**ADDENDUM # 1**

Contract No. DN01055  
TIP No.: A-0009CE  
Federal Aid No.: 3257220  
WBS Element: 32572.3.20  
County: Graham  
Description: Multi-Use Path with Culvert Extension Along NC 28 From SR 1238  
(Bill Crisp Rd) to SR 1230 (Hyde Town Rd) in Graham County

**Content Summary: Addition of the Electronic Ticketing System provision SP10 R20, Q&A regarding precast culvert, Q&A regarding extension of ICT 1 completion date and overall completion date**

TRIPLE 10 FT. X 9 FT. CONCRETE BOX CULVERT LEFT EXTENSION  
134°-00'-00" SKEW

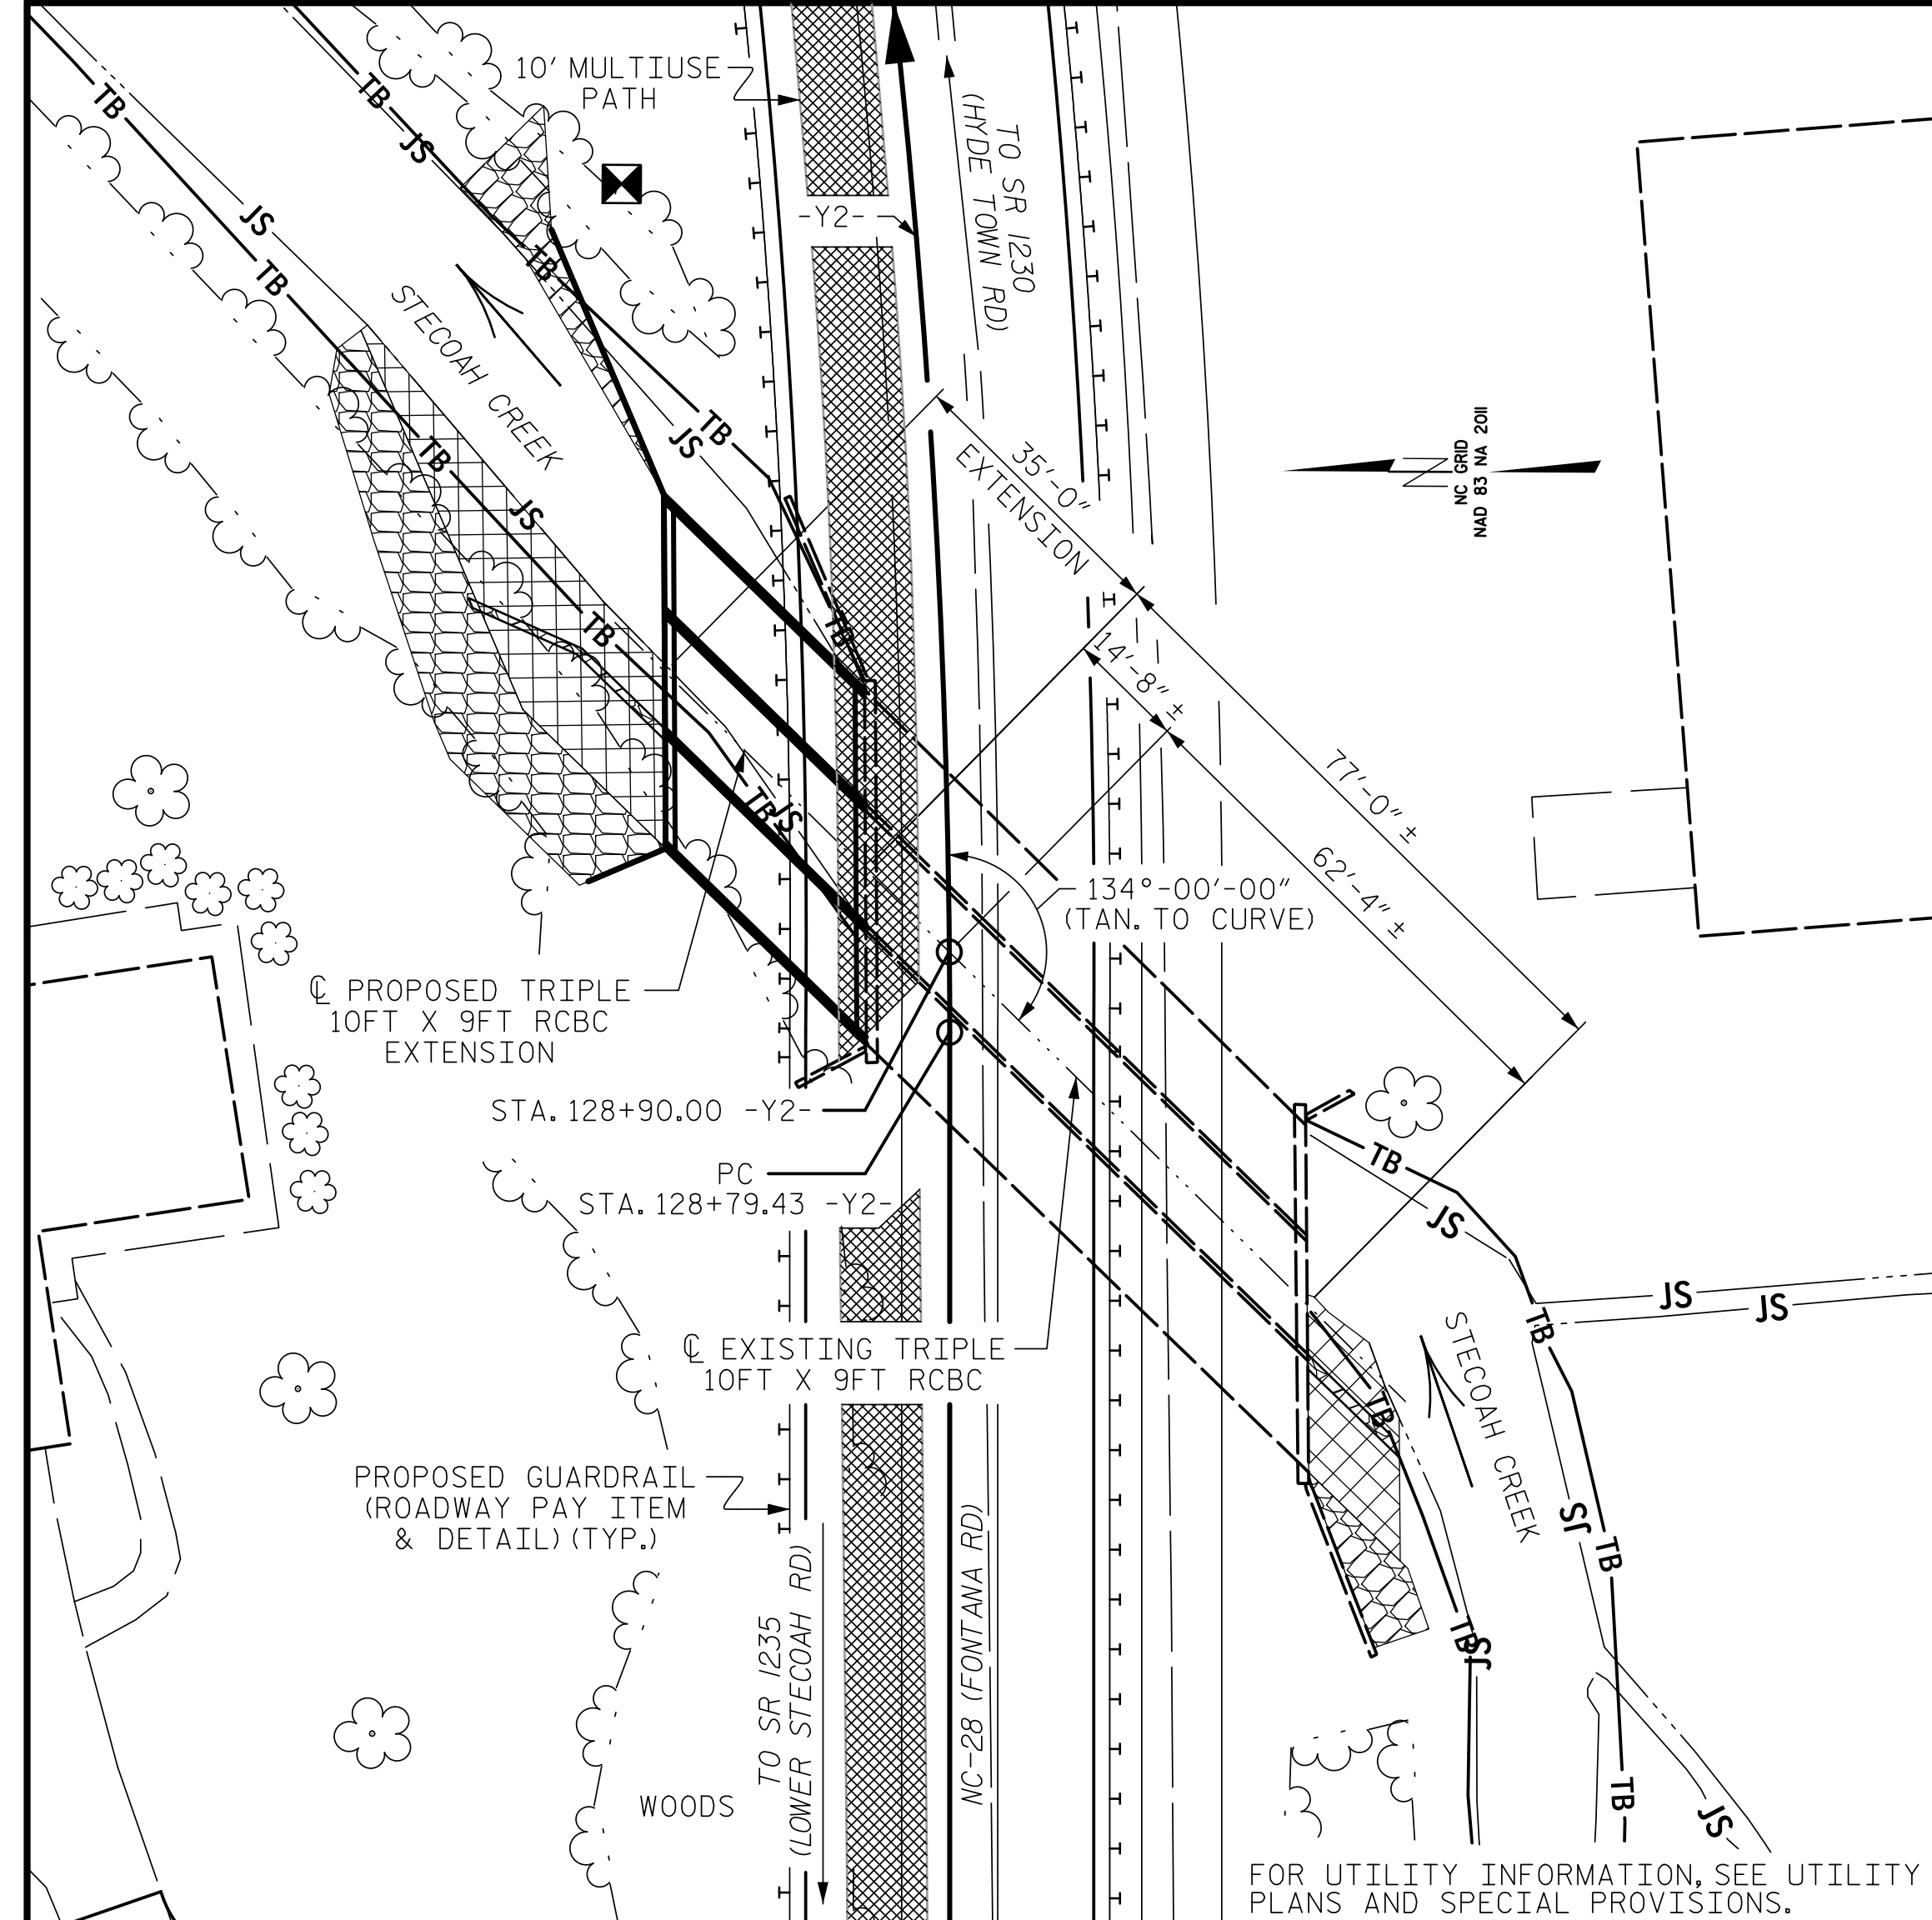
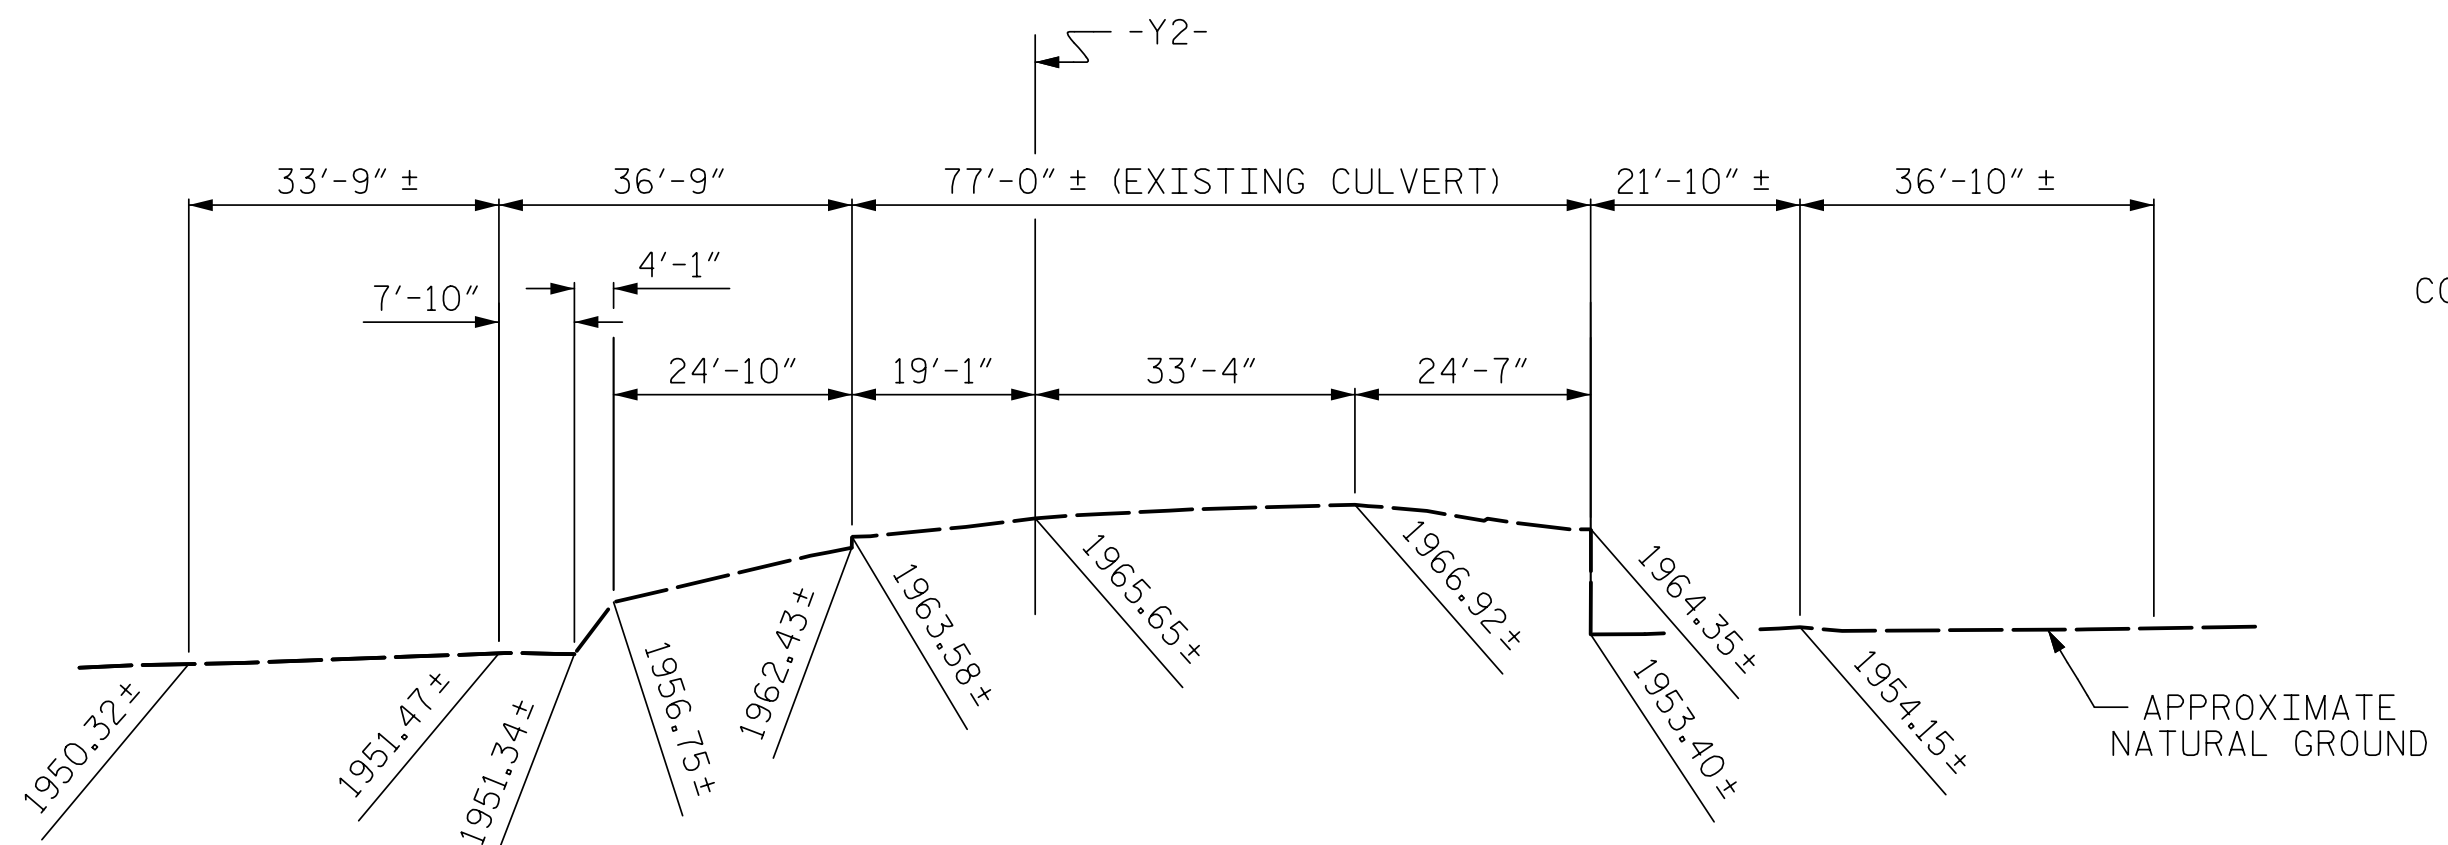
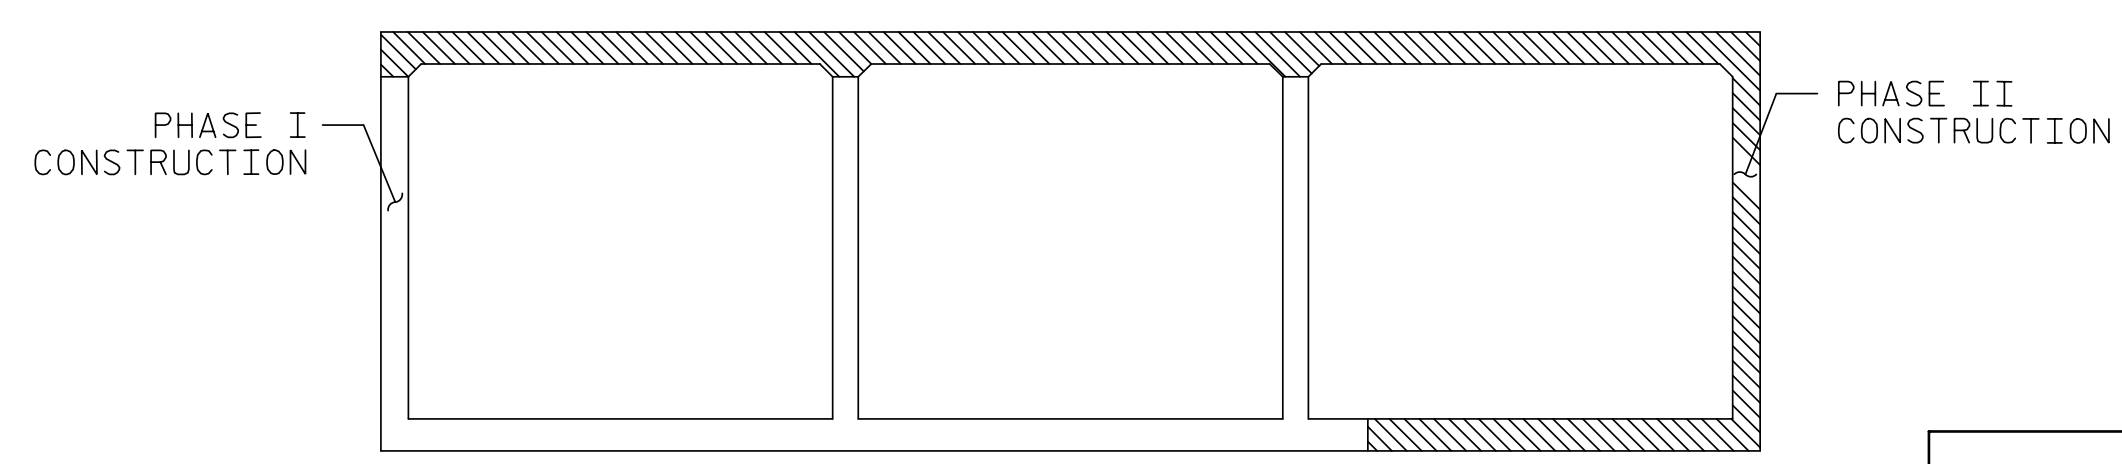
3. A bidder has posed the following question: "What is needed from us to provide a precast box culvert solution in place of the cast in place box culvert? Does this

need to be submitted to you before the letting date or is this something that would need to be worked out after the project award?" The **Department's response** is as follows: **Since this is a culvert extension, and not a replacement, the Department is removing the option for precast.** (See attached **revised culvert provisions** and revised culvert **plan sheet C1-1**).

- IF APPROVED BY THE ENGINEER, THE CONTRACTOR MAY USE THE EXISTING WINGS AS TEMPORARY SHORING FOR THE CONSTRUCTION OF THE CULVERT EXTENSION. IN THIS CASE, THE BOTTOM SLAB OF THE EXTENSION SHALL BE POURED AT LEAST 72 HOURS PRIOR TO CUTTING THE WINGS. THE WINGS MAY BE CUT EARLIER PROVIDED THE SLAB CONCRETE STRENGTH HAS REACHED A MINIMUM COMPRESSIVE STRENGTH OF 1500 PSI.
